UNITED STATES PATENT AND TRADEMARK OFFICE

| APPLICATION NO. | FILING DATE | FIRST NAMED INVENTOR | ATTORNEY DOCKET NO. | CONFIRMATION NO. |
|-----------------|-------------|----------------------|---------------------|------------------|
| 10/743,591 | 12/22/2003 | Jeff Fries | 133197/GETS 5319.1 | 7577 |

| Office Action Summary | Application No. | Applicant(s) | |

DETAILED ACTION

FIG. 5

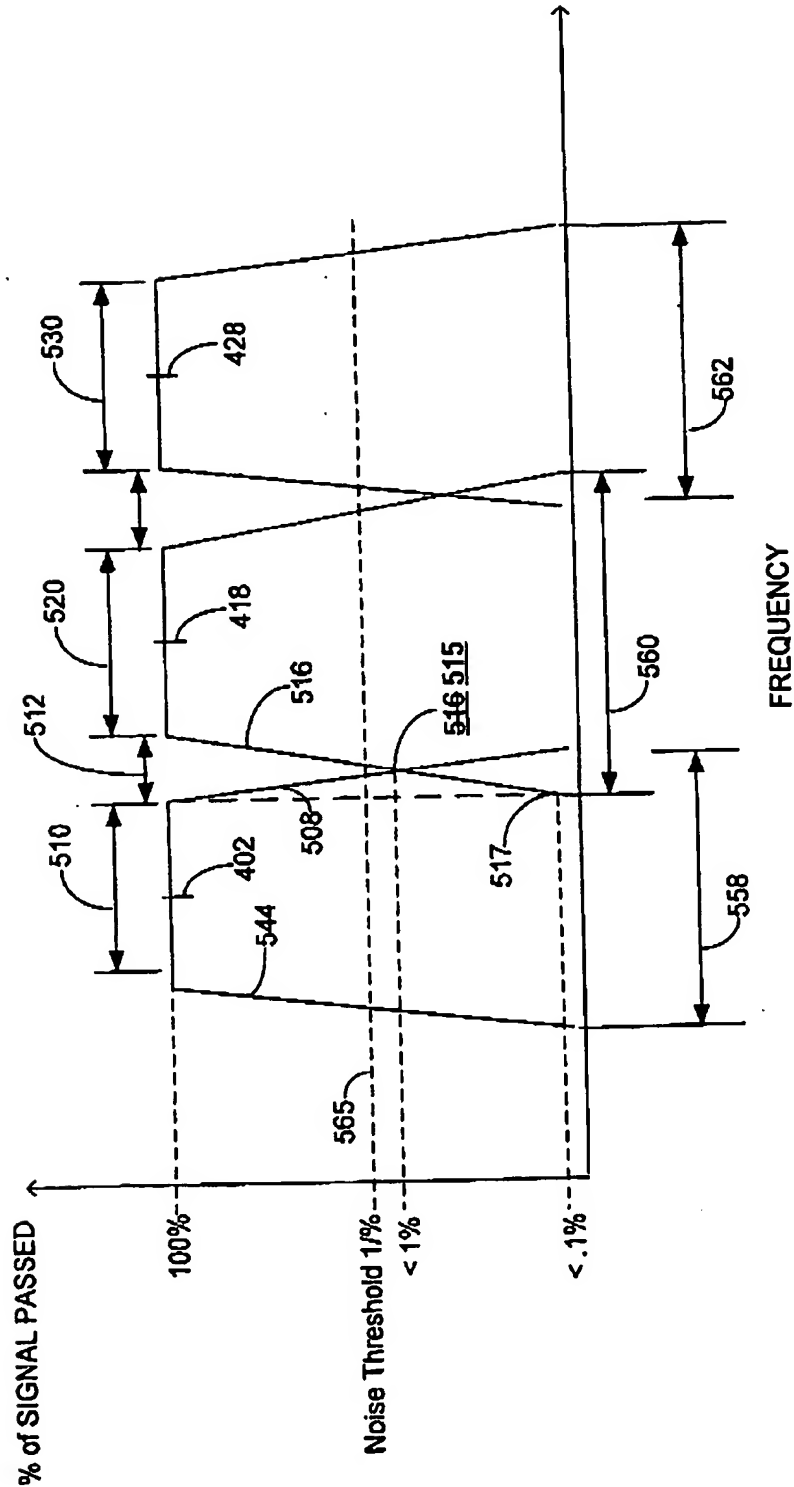
drawing correction approved
 ntu 8/18/06
